Department of Transportation

MEMORANDUM

SUBJECT: ZC Case No. 15-27B – 350 Morse Street NE (Market Terminal Building C2)

Figure 1 – Site Plan (Source: CTR, Gorove/Slade, Figure 7, 3/9/20)

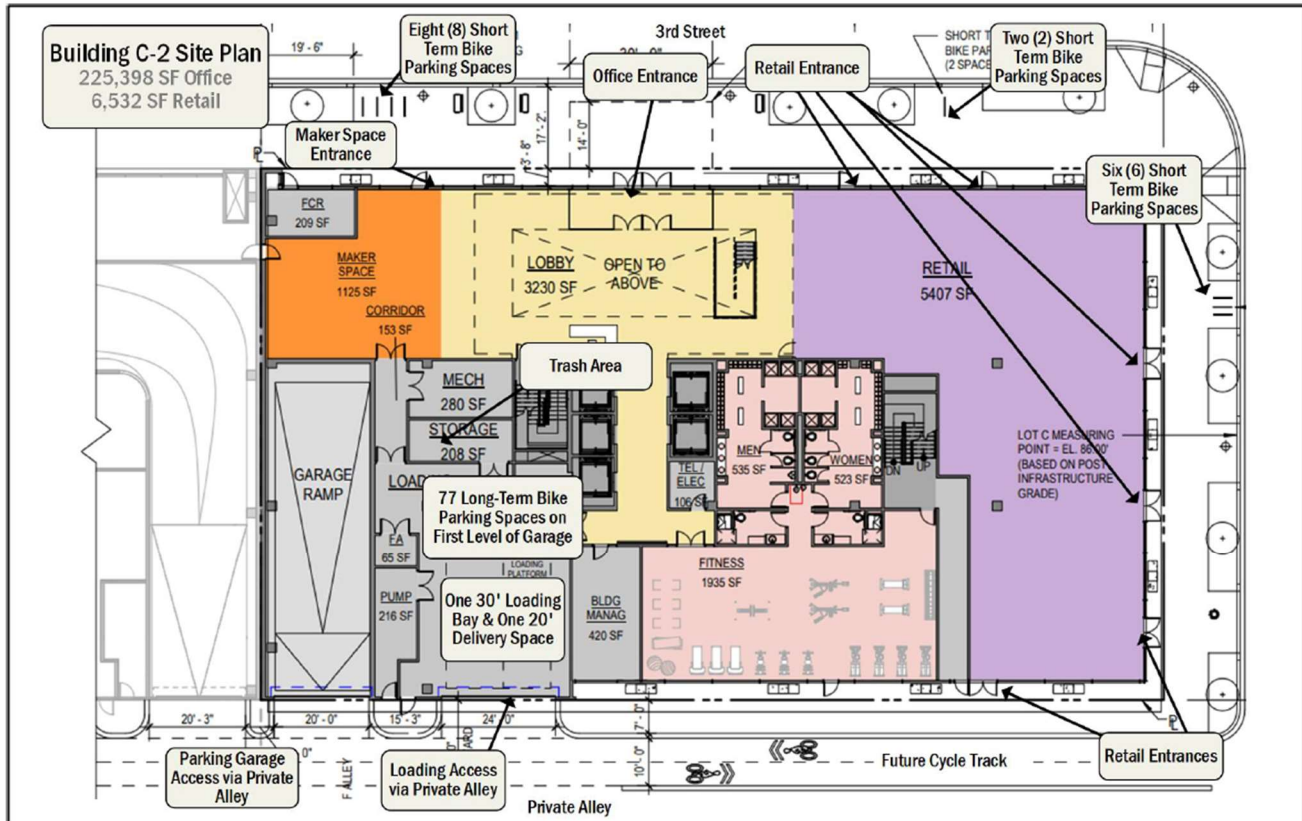
The building is designed so that all loading and trash pick-up activities take place in the dock area off the rear alley. Since the loading area has been designed for back-in truck maneuvers from the alley, the Applicant should coordinate the design of the cycle track to include special striping and markings at the parking garage and loading dock entrances, as necessary, and include strategies in the LMP to address this conflict.

Since Building C2 is providing less than the number of loading berths required under ZR16, includes back-in loading across the cycletrack, is not providing a direct connection between the retail units and the loading bays (instead via the building lobby), and is sharing loading space with building C1, DDOT has requested the Applicant implement an LMP to address these items. DDOT finds that the following LMP, proposed by the Applicant in the May 20, 2020 Transportation Memorandum (Exhibit 26C), adequately resolves DDOT's concerns:

Additionally, the concrete barrier between the cycletrack and vehicle travel lanes in the private alley is currently shown as blocking accessible pedestrian travel across the alley. DDOT requests a condition that the Applicant revise the cycletrack design to pull back the concrete barrier back on both the north and south sides of Neal Place to allow for a clear pedestrian crossing and flexposts be installed at the ends of the barriers.

- Implement the Loading Management Plan (LMP) as proposed in the Applicant's May 20, 2020 Transportation Memorandum (Exhibit 26C), for the life of the project, unless otherwise noted;
- Implement the Transportation Demand Management (TDM) Plan as proposed in the Applicant's May 20, 2020 Transportation Memorandum (Exhibit 26C), for the life of the project, unless otherwise noted; and
- The cycletrack design will be revised to pull back the concrete barrier on the south side of the private alley and Neal Place intersection to allow for a clear and accessible pedestrian path across the alley. Flexposts will be installed at the end of the concrete barrier.

- A loading dock manager will be designated by the building management who will be on duty during delivery hours. The dock manager will be responsible for coordinating with vendors and tenants to schedule deliveries and will work with the community and neighbors to resolve any conflicts should they arise.

- The dock manager will monitor inbound and outbound truck maneuvers and will ensure that trucks accessing the loading dock do not block vehicular, bike, or pedestrian traffic along the private alley except during those times when a truck is actively entering or exiting a loading berth.

Figure 4 – Existing and Planned Pedestrian Facilities (Source: CTR, Gorove/Slade, Figure 26, 3/9/20)

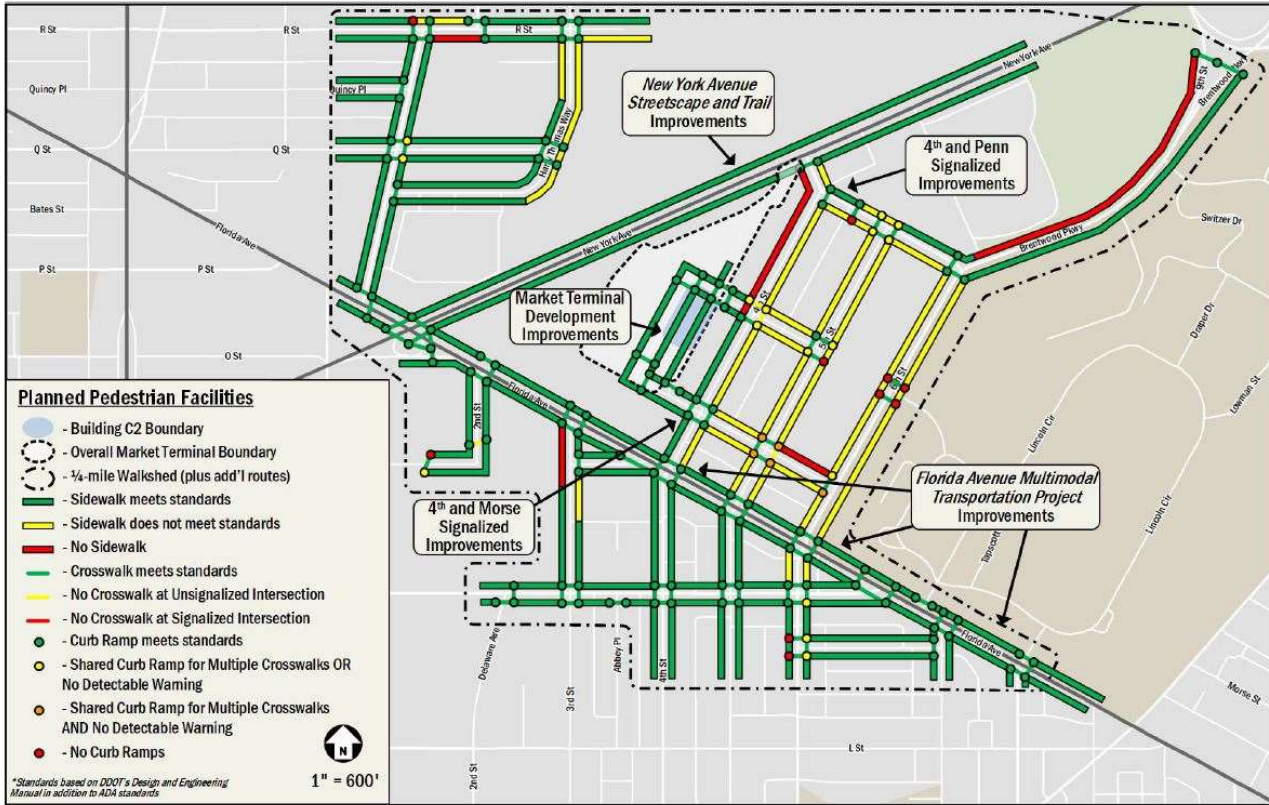
The Applicant’s inventory of existing and planned pedestrian infrastructure, as shown in Figure 4 below, demonstrates that most sidewalks in the immediate vicinity of the site are or will be constructed with appropriate widths and include accessible curb ramps. East of the site, in the vicinity of Union Market, sidewalks and pedestrian facilities will be upgraded when the adjacent blocks redevelop. These pedestrian facilities will be in accordance with the Union Market Streetscape Guidelines.

It is also noted that the eastern corners of the intersection of Neal Place and the private alley have not been upgraded to ADA compliance with the recently constructed adjacent projects. DDOT will work with the other property owners outside of this application to get the missing curb ramps installed. Through the two concurrent applications for Buildings C2 and D, the Applicant will ensure the western side of the private alley is ADA compliant by making the sidewalk flush with private Neal Place.
